SERVICE BULLETIN

EM20-007

2015-2020 ROGUE; AIR DUCT REPLACEMENT

APPLIED VEHICLES: 2015-2020 Rogue (T32)

Figure 1

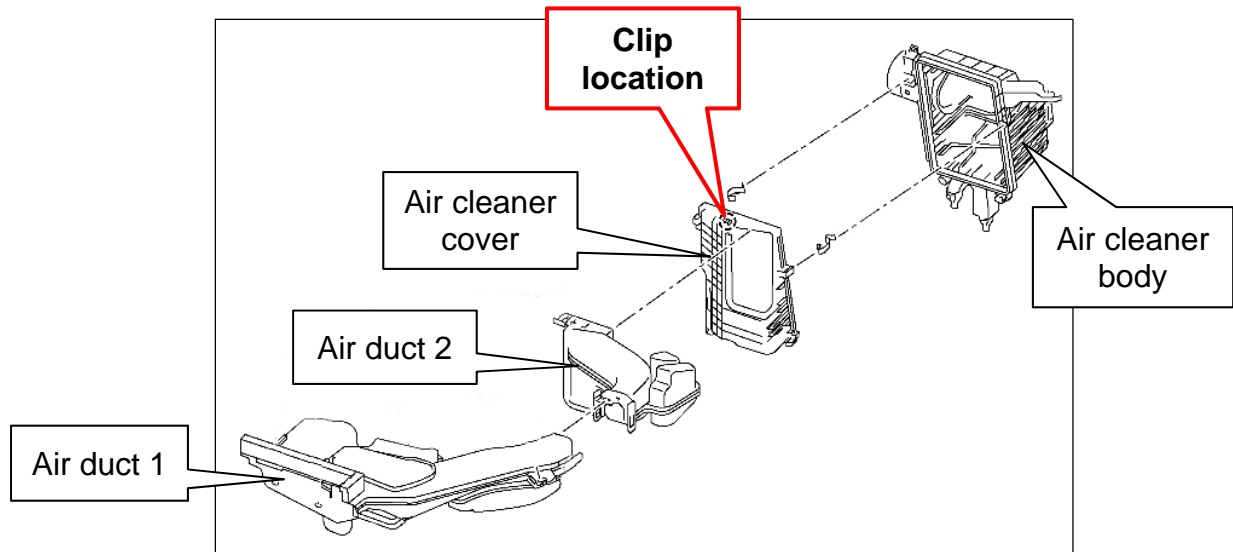
Air duct 1, air duct 2, or the air cleaner cover shown in Figure 1 needs to be replaced.

Inspect for a clip in the location shown in Figure 1 and Figure 2.

- If a clip is present, then the vehicle **IS** equipped with the updated parts; no further action is needed. Individual parts may be replaced as needed.
- If a clip is **NOT** present, then the vehicle is equipped with older parts. See **SERVICE PROCEDURE** on the next page.

Figure 2

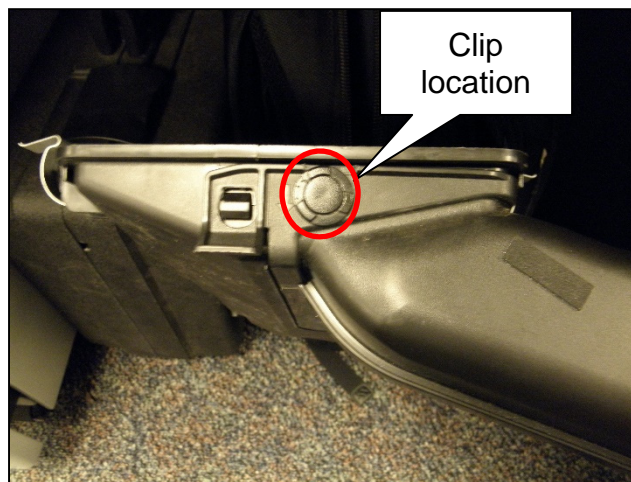
1. Inspect the air cleaner body for a clip in the location shown in Figure 1 and Figure 2.
 - If a clip is present, then the vehicle is equipped with the updated parts; no further action is needed. Individual parts may be replaced as needed.
 - If a clip is **NOT** present, then the vehicle is equipped with older parts. All components listed in the **PARTS INFORMATION** section must be replaced.
 - For removal and installation, refer to the Electronic Service Manual (ESM) section **REPAIR > ENGINE > ENGINE MECHANICAL > REMOVAL AND INSTALLATION > AIR CLEANER AND AIR DUCT**.
2. Install the new clip into the location shown in Figure 2.
